Saint Ignatius' College Riverview Redevelopment Stage 2

State Significant Development Assessment
SSD 10424

October 2021

Published by the NSW Department of Planning, Industry and Environment

Figure 19 | Proposed Stage 2 layout (Source: Applicant's RtS 2021)

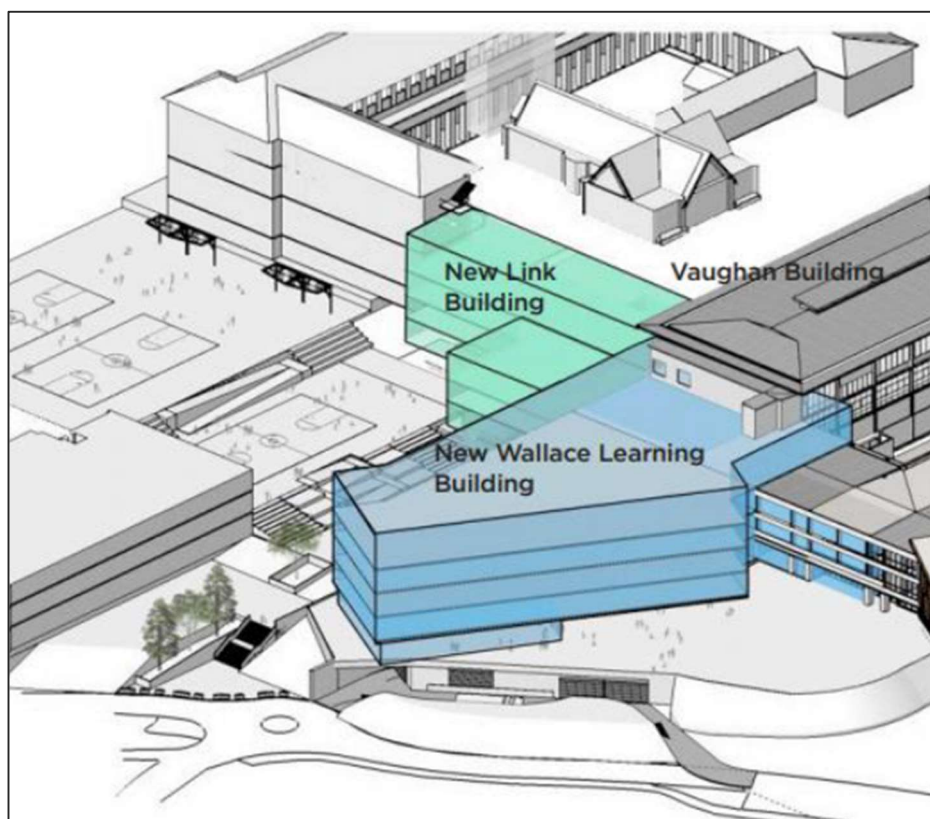
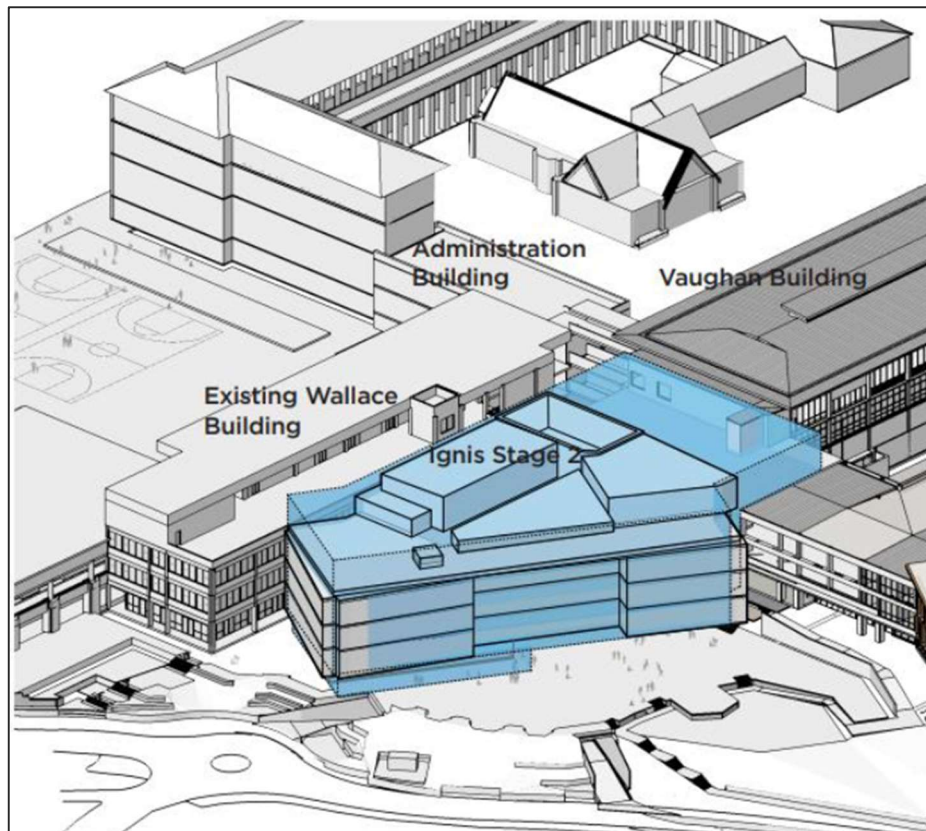
During the EIS exhibition, the Department noted inconsistencies between the Stage 2 application layout and the Concept Proposal (SSD 7140 Mod 3). The Department specifically raised concerns regarding the retention of the Wallace Building, which was otherwise approved for demolition as part of the Concept Proposal.

In response, the Applicant's RtS and SRtS provided details to clarify the consistency of the Stage 2 application with the overarching Concept Proposal. The Applicant advised that the Concept Proposal was modified (SSD 7140 Mod 3) to retain the existing Wallace Building as a shunt or decanting space to accommodate students while the construction of the new Ignis Building would occur. The Applicant proposes the existing Wallace Building to be demolished after the new Ignis Building is operational but as part of a future stage of the Concept Proposal. The RtS confirmed that the proposed new Ignis Building (along with the internal refurbishments to the O'Neil Building) is the only component of the current Stage 2 application.

Figure 20 | Site section comparing the scale of Stage 2 and other existing buildings (Source: Applicant's RtS 2021)

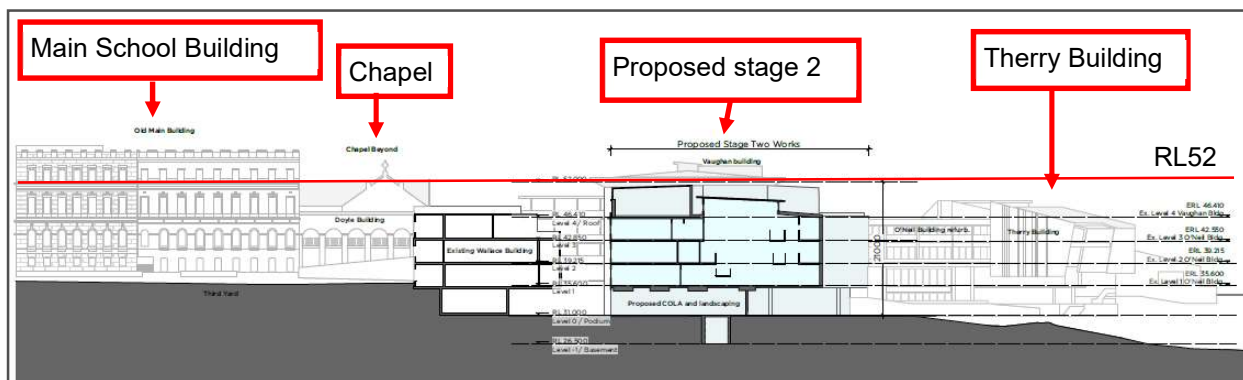
The Applicant has not provided any detailed reasons to justify the exceedance of the building height beyond the maximum stipulated building height in the LCLEP.

The Department notes that clause 42 of the Education SEPP states that *“Development consent may be granted for development for the purpose of a school that is State significant development even though the development would contravene a development standard imposed by this or any other environmental planning instrument under which the consent is granted”*. Pursuant to clause 42, strict compliance with the LCLEP height control is not required in this instance.

Figure 23 | Design concept for the rock shelter (Source: Applicant's RtS 2021)

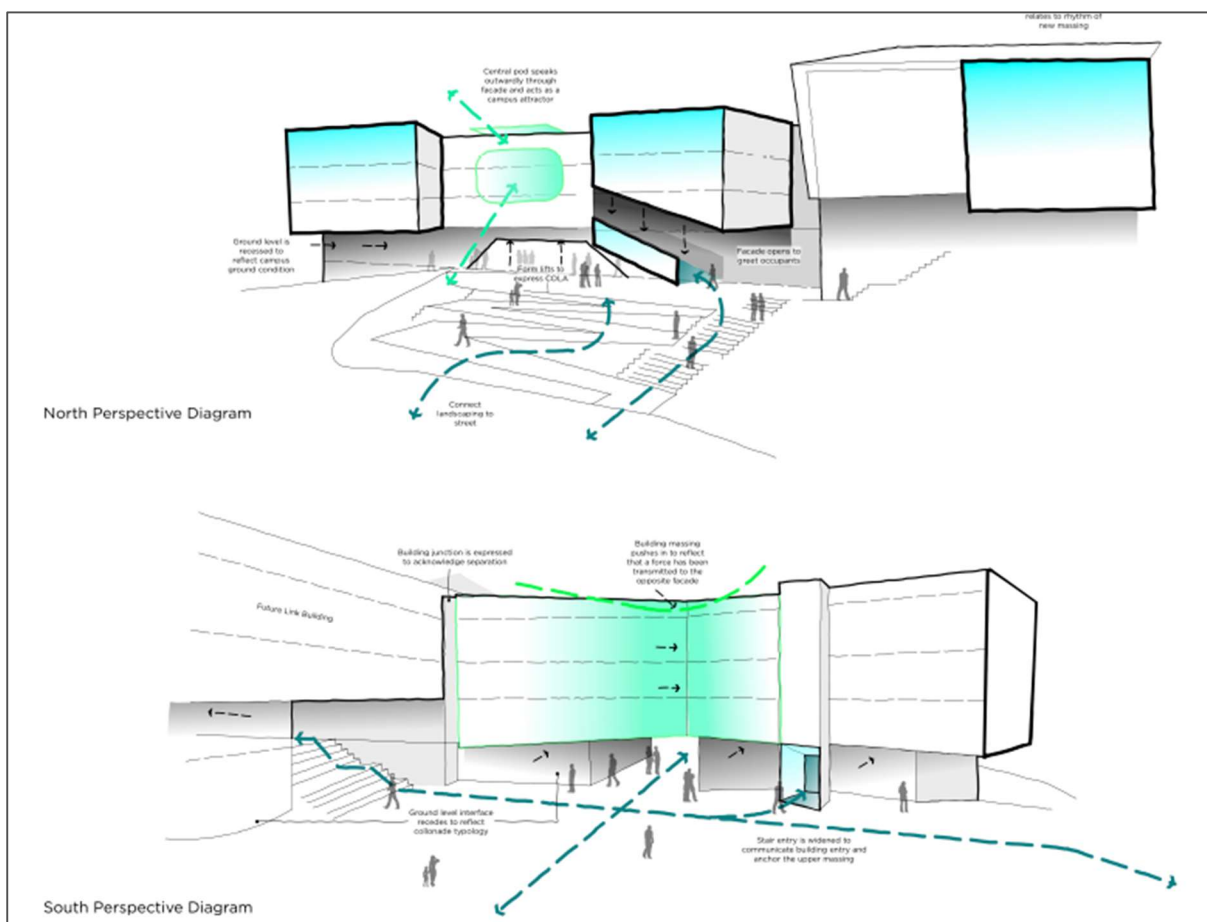
- the building should seek more opportunities to portray the Aboriginal knowledge (being the design theme) such as rock shelters and stories that connect the harbour with the campus.
- the sketch of the 'rock shelter' should be referenced in the floating building form.
- the key hierarchy of the building components should be visible in the building façade, being the ground plane, columns, soffit, floating built form, and facade treatments.
- a continuous soffit should be provided above the recessed ground floor to unify the overall building façade externally.
- conflicting elements such as circular columns support a building with a rectilinear language.
- the louvres to the façade of the atrium should be orientated for optimal shading and justify the departure from the horizontality.
- materials should reference the muted tones of the natural setting.

The overall development form, as identified in **Figure 23** does represent a rock shelter and connects well with the landscape areas on the podium, as iterated in the amended Design Analysis Report. Based on the comments from GANSW, the Department is satisfied that the building elements provide visual interest and make a positive contribution to the College.

Figure 24 | Additional overshadowing due to the new Ignis Building (shown in yellow) during winter solstice (21 June) (Source: Applicant's RtS 2021)

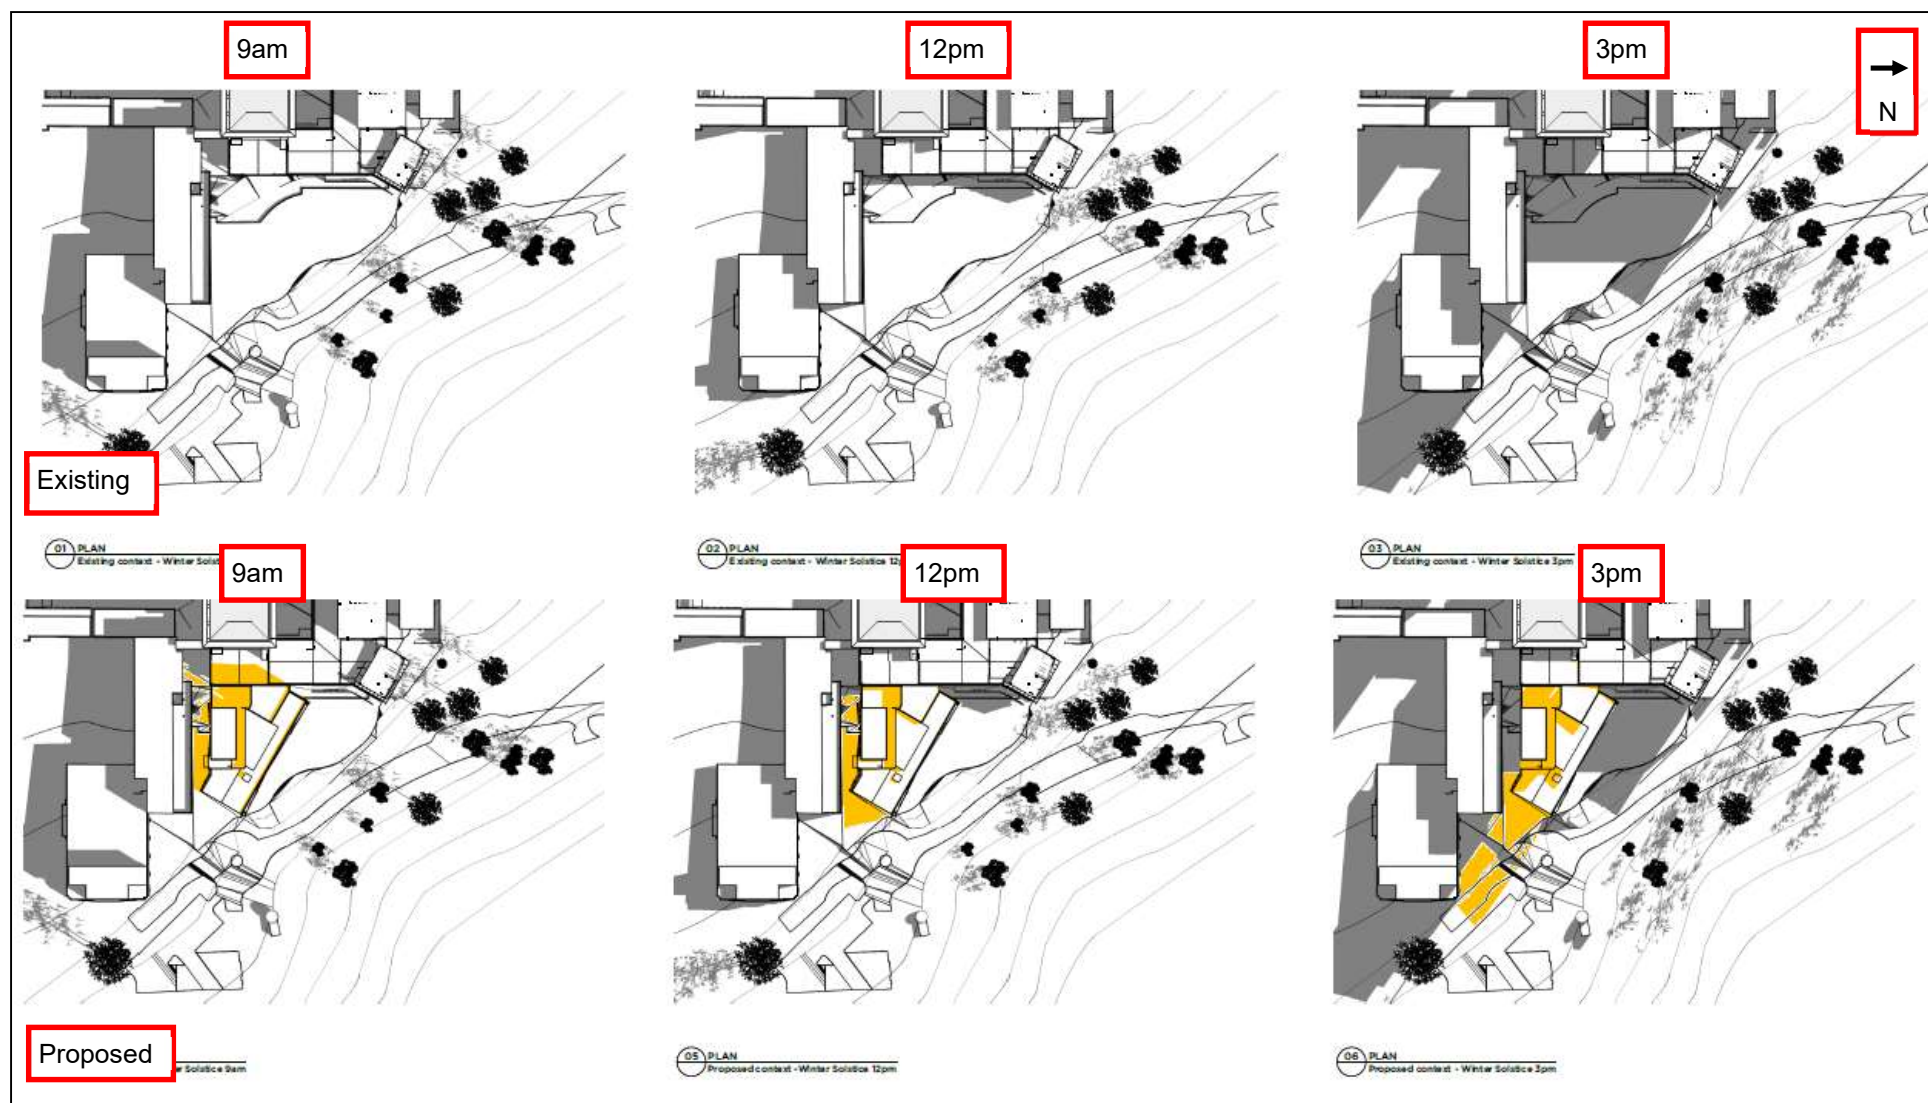
The Department has reviewed the existing and the proposed shadows and does not agree with the Applicant that the new Ignis Building would not have any additional overshadowing impact on the existing Wallace Building. The shadow diagrams clearly indicate that the north facing general learning areas of the existing Wallace Building would be overshadowed due to the new Ignis Building.
